ENVIRONMENTAL REVIEW TEAM REPORT

BREEZY HILL
NEW HARTFORD AND CANTON, CONNECTICUT

AUGUST 1980

APPROXIMATE DRAINAGE AREA OF THE POND IN THE
SOUTHEASTERN CORNER OF THE BREEZY HILL SUBDIVISION
SITE. (AREA INCLUDES APPROXIMATELY 160 ACRES.)

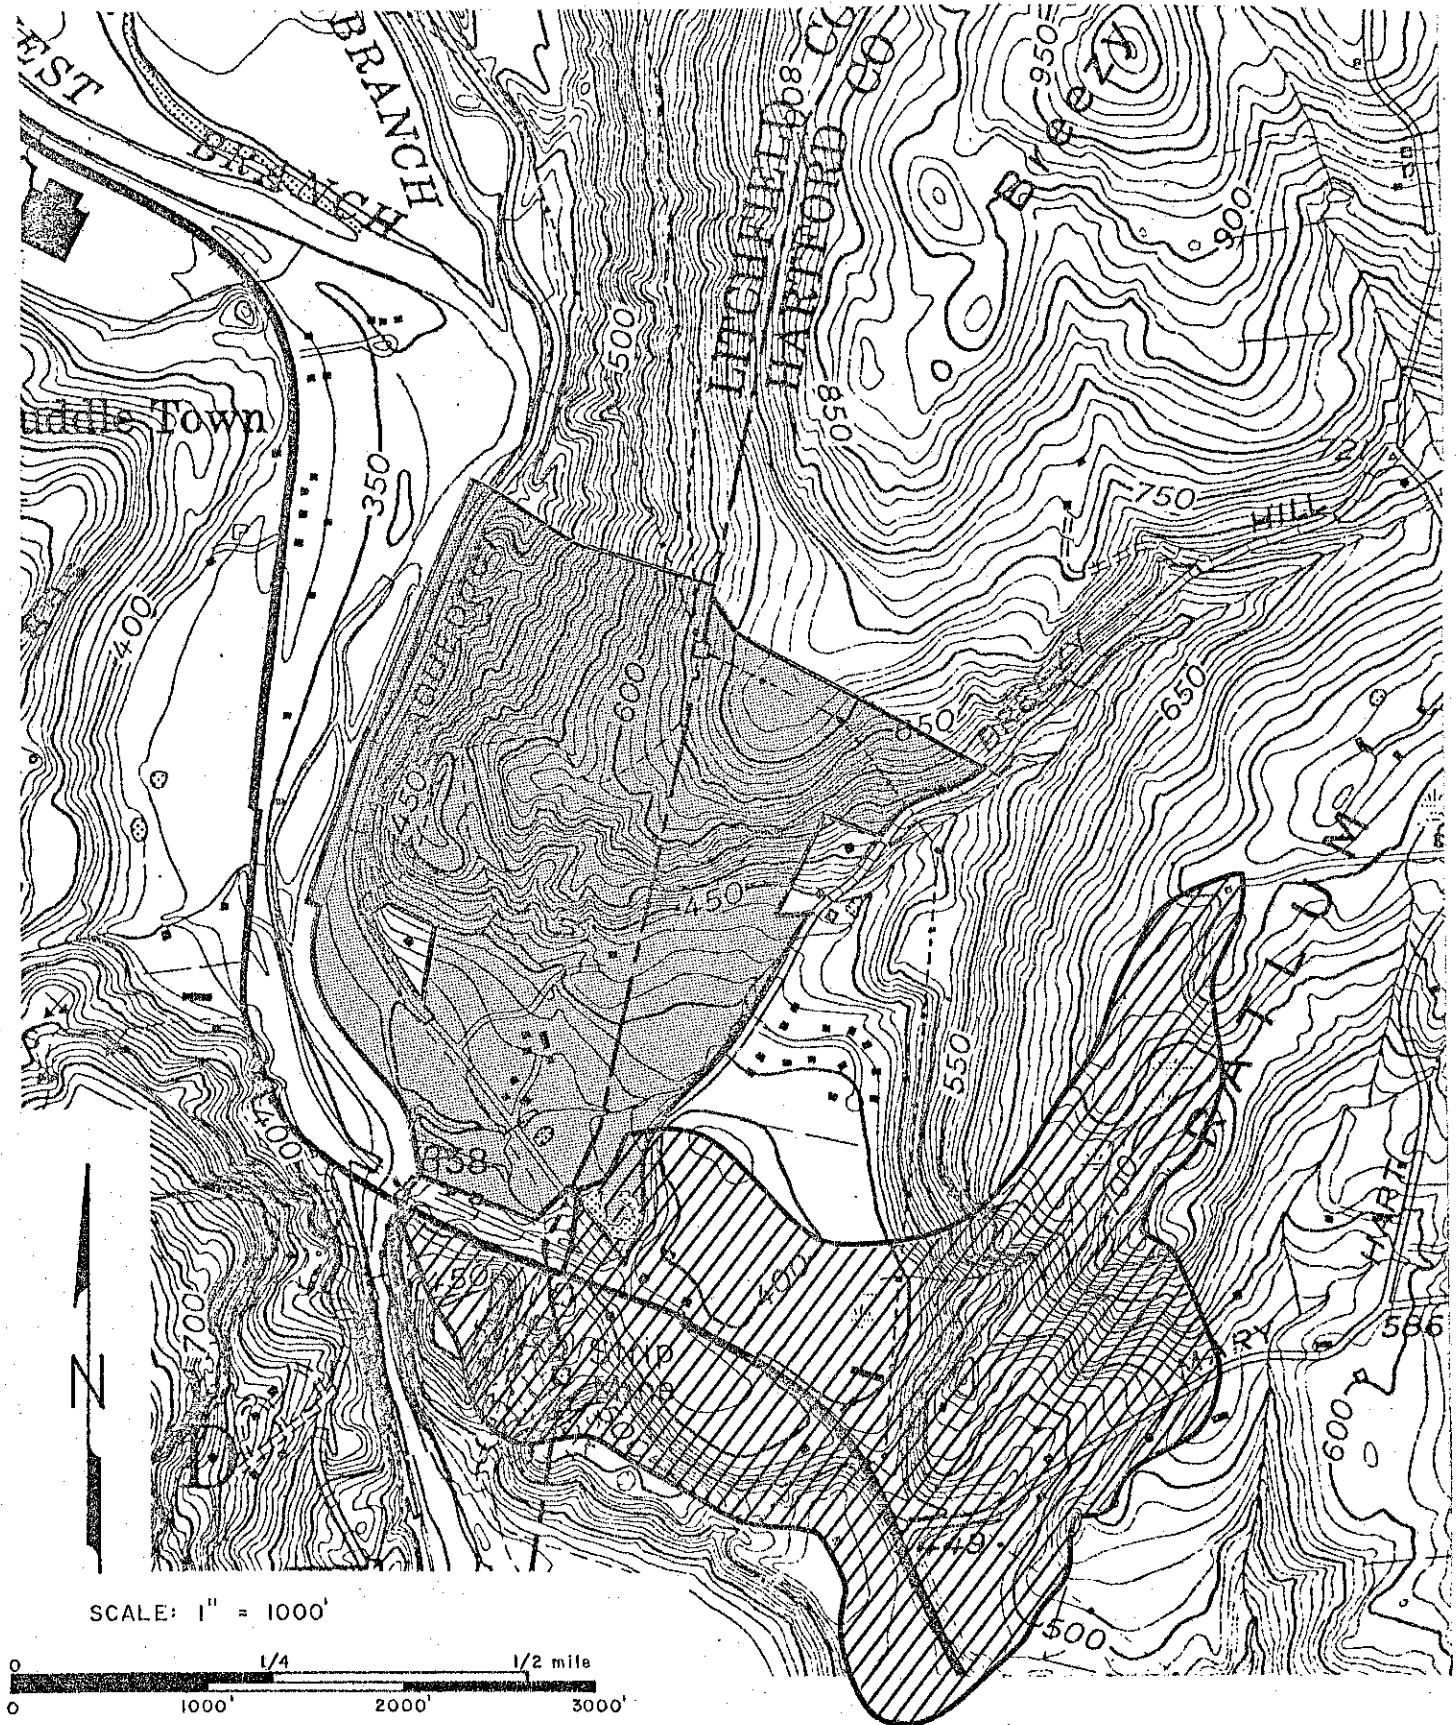
sediment or retention basin may be many times larger than the runoff contributing portion of the subdivision (the upstream area to the Breezy Hill site is more than seven times as large). In such a case, it would certainly be unfair to demand overdesign from the developer, as this may be prohibitively expensive. Moreover, it may be impossible to estimate the ultimate amount of upstream development that would occur. Thirdly, reliance on downstream measures may allow serious flooding or sedimentation problems to arise in the middle sections of the watershed. Finally, the question of maintenance of the basins becomes complex: should the developer be responsible? Should the town take care of the facilities? Should upstream landowners contribute to the upkeep? The resolution proposed in this case is that the owners of the lots on which the basins are located should bear total responsibility for their maintenance. This approach seems both unfair and impractical--lots with such legal ramifications are likely to go unsold.

The developers in this case are the proponents of overdesign and hence cannot object to it as being "unfair". However, to the extent that any town decision may set a precedent, it may be unwise to free upstream developers of environmental responsibilities based on the design of a downstream drainage system. Such a precedent may discourage individual initiative in other areas. Also, as mentioned above, in a large watershed, serious problems may still occur in central sections.

therefore allow some "surcharging" in lots 18-22. Lot 18 may be most affected since the new and old channels would be relatively close together. In the other lots, however, it is not clear whether the "surcharge" would cause problems. The engineering report on the deep pits dug in the Phase I section does not indicate that the groundwater levels are presently troublesome in the area of lots 18-22. Hence, the additional groundwater flow through those lots might never be problematic.

Considering all of the factors listed above, it seems that the most practical solution with regard to this subdivision proposal would be to scale down the drainage plan and tailor it more to the needs of this site and less to hypothetical future needs arising from upstream development. In view of the minimal peak flow changes that the Breezy Hill subdivision itself would cause, the extensive rechanneling is not necessary. Provision could be made for a much smaller sediment basin with a controlled outlet to prevent peak flow increases. Perhaps a small channel from the existing stream near lot 23 could be extended to the existing pond to direct exceptionally heavy flows to that pond (there appears to be a great deal of storage space available in the pond). The bed elevation of the new channel could be calculated on the basis of the estimated level of the present stream during a 10 year or 25 year storm. Other ideas may suggest themselves to the developers, but the present plan seems needlessly ambitious and may produce more of an environmental disruption than a benefit.

VEGETATION TYPE MAP

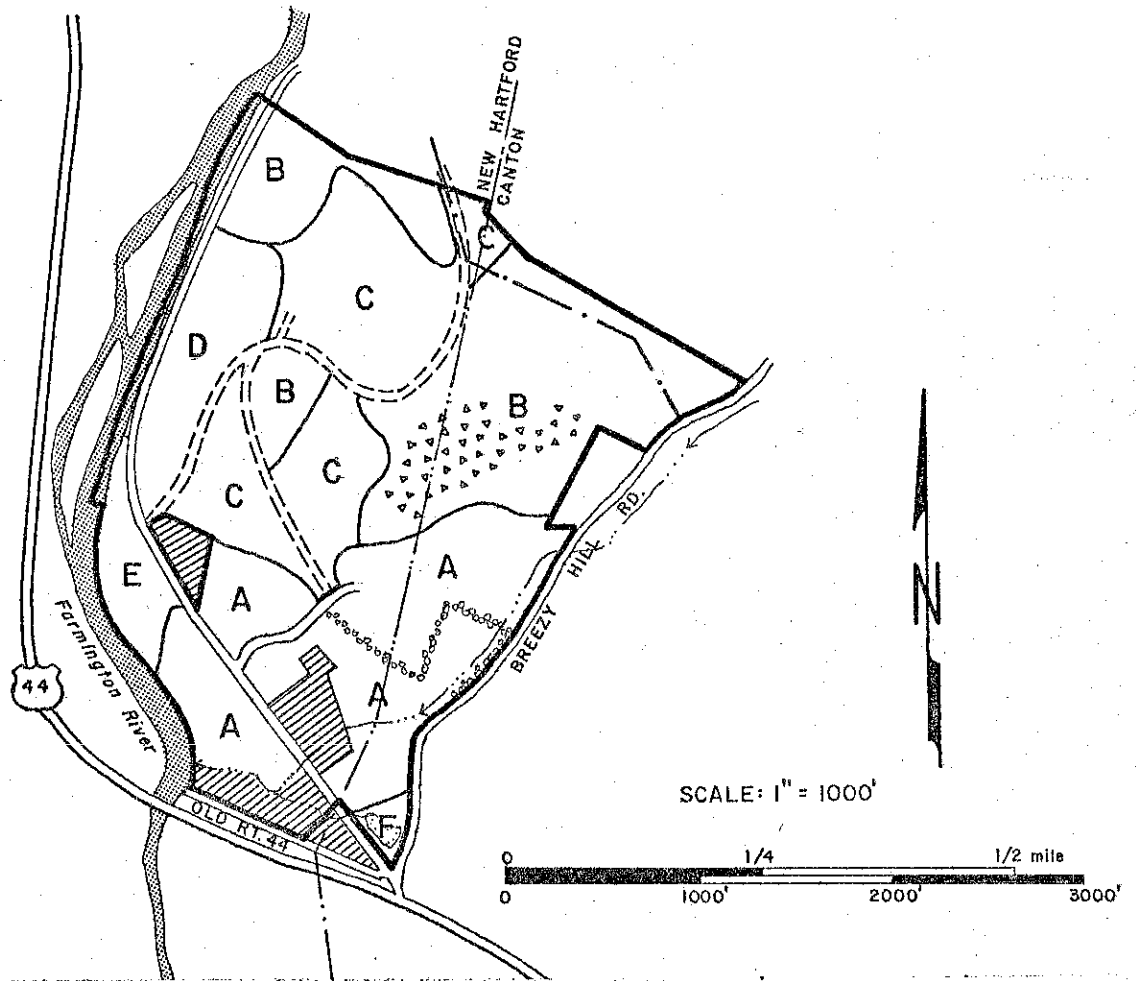
The scattered dense patches of mountain laurel which are present in vegetation type B and C have high aesthetic value and should be retained if possible. The flowering of these shrubs may be stimulated by allowing direct sunlight to reach them. This may be accomplished by complete or partial removal of the overstory trees over these shrubs.

The lack of adequate moisture reserves in the extremely rocky portions of vegetation type B (see Vegetation type map), has a limiting effect on tree growth. In these areas, many of the pine trees which are present are stunted and of poor quality.

Windthrow is a potential hazard in the steeply sloped, shallow to bedrock areas of vegetation type B. The trees in these areas are unable to become securely anchored because their root systems are shallow. The windthrow hazard is lessened where underlying bedrock is highly fractured because tree roots can penetrate deeper into cracks, making trees more stable.

There are a considerable number of sawtimber size trees in vegetation type B, and a few in vegetation type C, which are dead or have large dead branches. These trees will become a hazard if buildings, roadways, or utility lines are constructed near them. Potentially hazardous trees should be removed prior to the completion of any construction to avoid this hazard.

A fuelwood thinning in vegetation type C (softwoods-hardwoods) that would remove approximately one third of the total volume, or between five and seven cords per acre, would be beneficial. This thinning will reduce competition between residual trees for space, sunlight, water and nutrients, allowing them to respond by growing more vigorously and becoming more stable over time. This thinning should be focused on removing unhealthy and poor quality trees and those trees which are directly competing with healthy high quality trees.
